**Petition of BNE Energy Inc. for a  
Declaratory Ruling for the Location,  
Construction and Operation of a 4.8 MW  
Wind Renewable Generating Project on  
Winsted-Norfolk Road in Colebrook,  
Connecticut (“Wind Colebrook North”)**

**Petition No. 984**

**PRE-FILED TESTIMONY OF NOISE CONTROL ENGINEERING, INC.,  
BY MICHAEL BAHTIARIAN, INCE Bd. Cert.**

hub height      h = 328    ft  
 sound power level      Lw = 104    db  
 absorption coefficient      a = 0.005    db/m

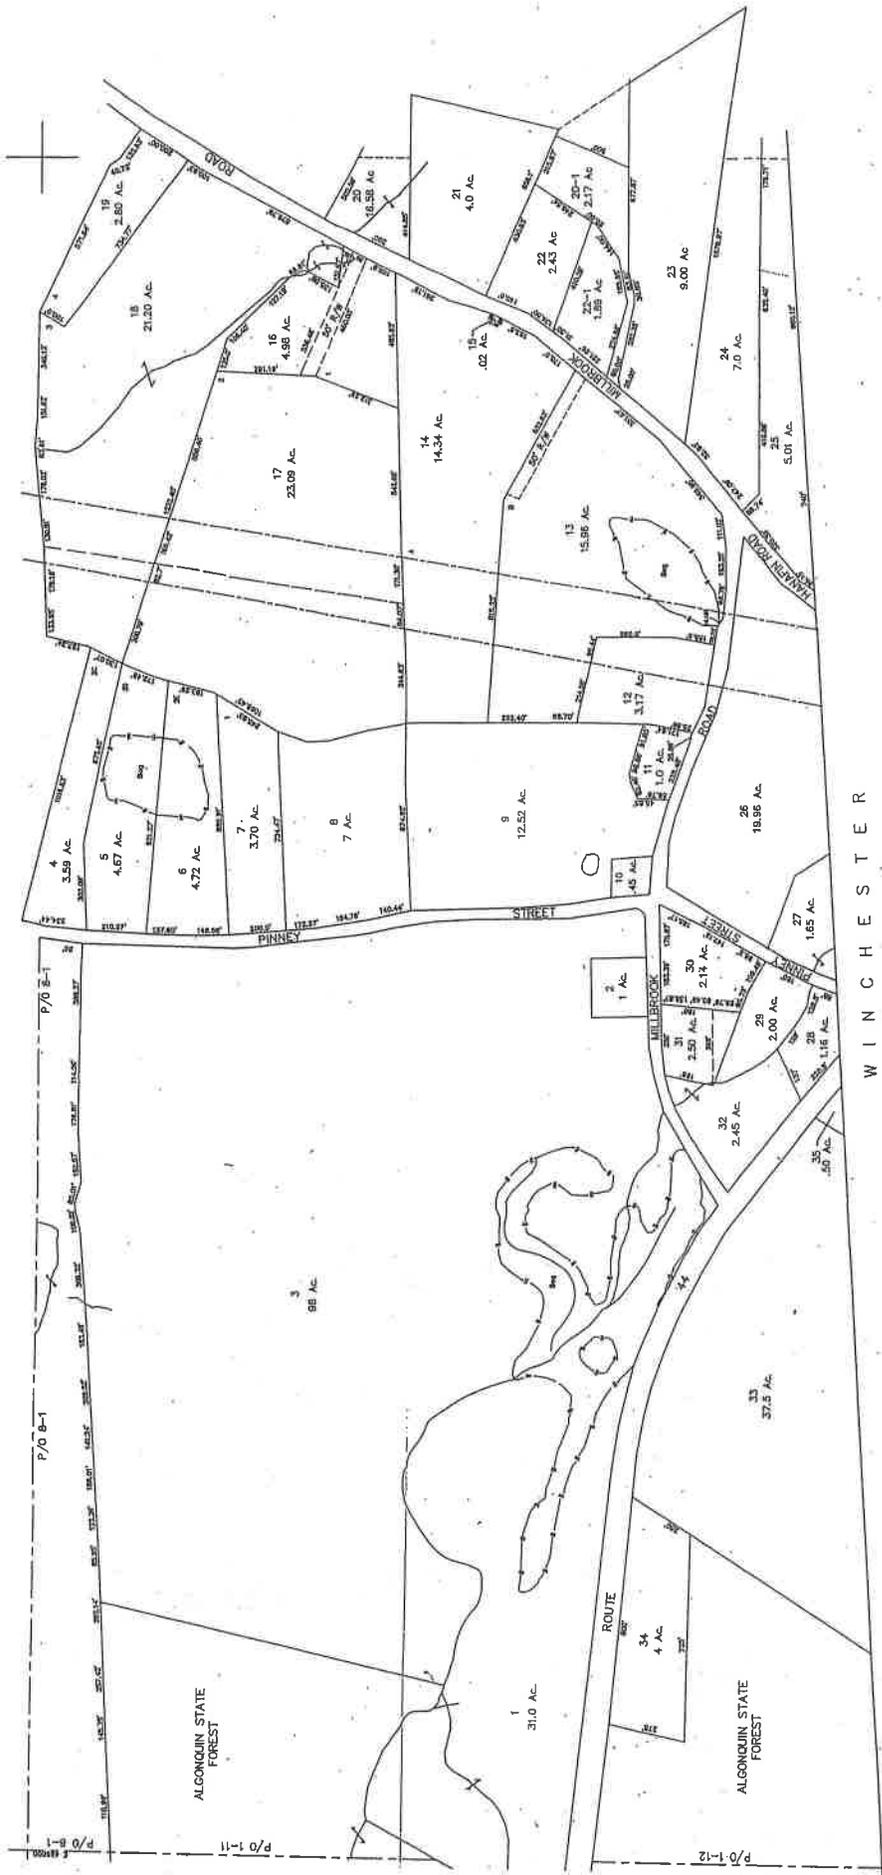
The value of atmospheric absorption factor used for the Wind Colebrook North is 5 dB/km (0.005 dB/m) which is found at the top of the sound computation worksheets under the heading absorption coefficient. Based on examination of ISO-9613-2, the factor appears to be for the condition of 20°C (68°F), 70% RH and 1,000 Hertz octave band. According to ISO-9613-2

when performing the computations in overall A-weighted SPL the atmospheric absorption factor for the 500 Hertz octave band should be used. Accordingly, the value of the factor that should have then been used for the above meteorological conditions is 2.8 dB/km. Further, for a worst case situation the minimum factor should be used which would have been at meteorological conditions of 10°C (50°F), 70% RH. In this case the value would be 1.9 dB/km. In many of my evaluation studies I have not taken into account this factor (i.e. the coefficient is set to 0 dB/km). This would provide an even more conservative assessment.

The lower the atmospheric absorption factor the higher the predicted SPL. The report's conclusion states that the computation is a "worst case analysis". This does not appear to be the case. If the 1.9 dB/km value were to be used the predicted SPL would be 1 to 5 decibels higher. If no atmospheric absorption was taken into account (0 dB/km) the predicted SPL would be 2-8 decibels higher.
